APPLICATION/APEAL TO THE BOARD OF ADJUSTMENT

234-130

Location address: 409816 9820 NO Royce Dr

REMODELING/ADDITION
SINGLE FAMILY RESIDENCE

SITE PLAN SHEET
C1.00

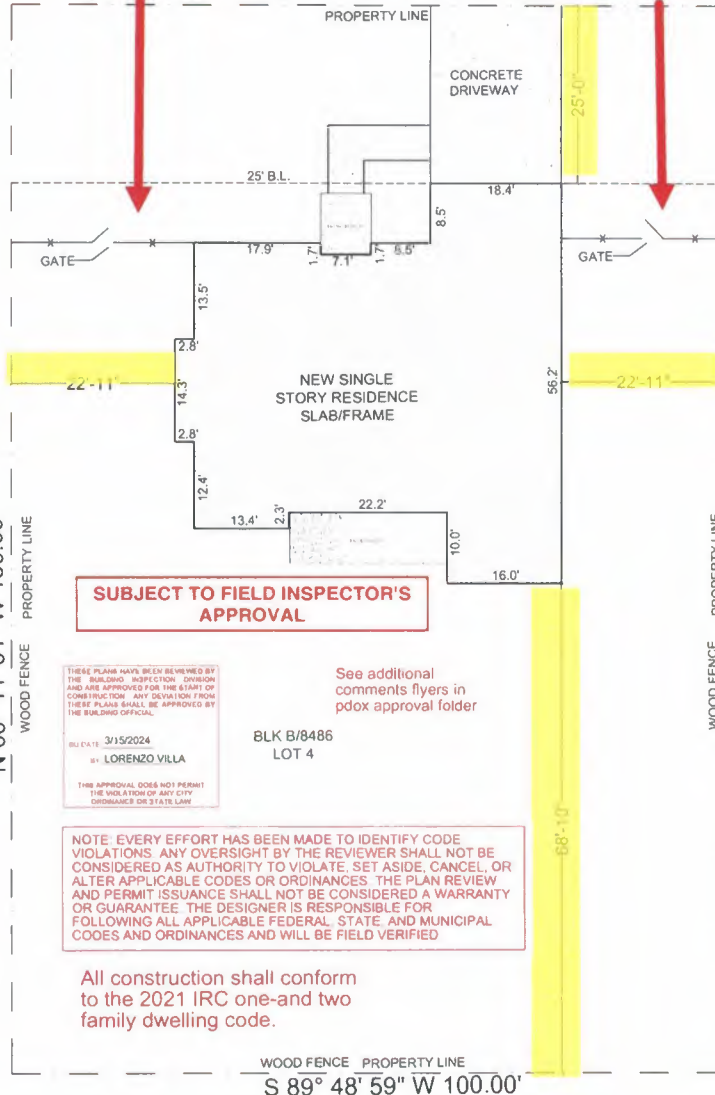
Description: *30' front yard setback required. Plan reviewer noted on site plan and was missed in the field*

BUILDING LINE IS 30'

BUILDING LINE IS 30'

PUSH STRUCTURE TO 30' FROM PROPERTY LINE.
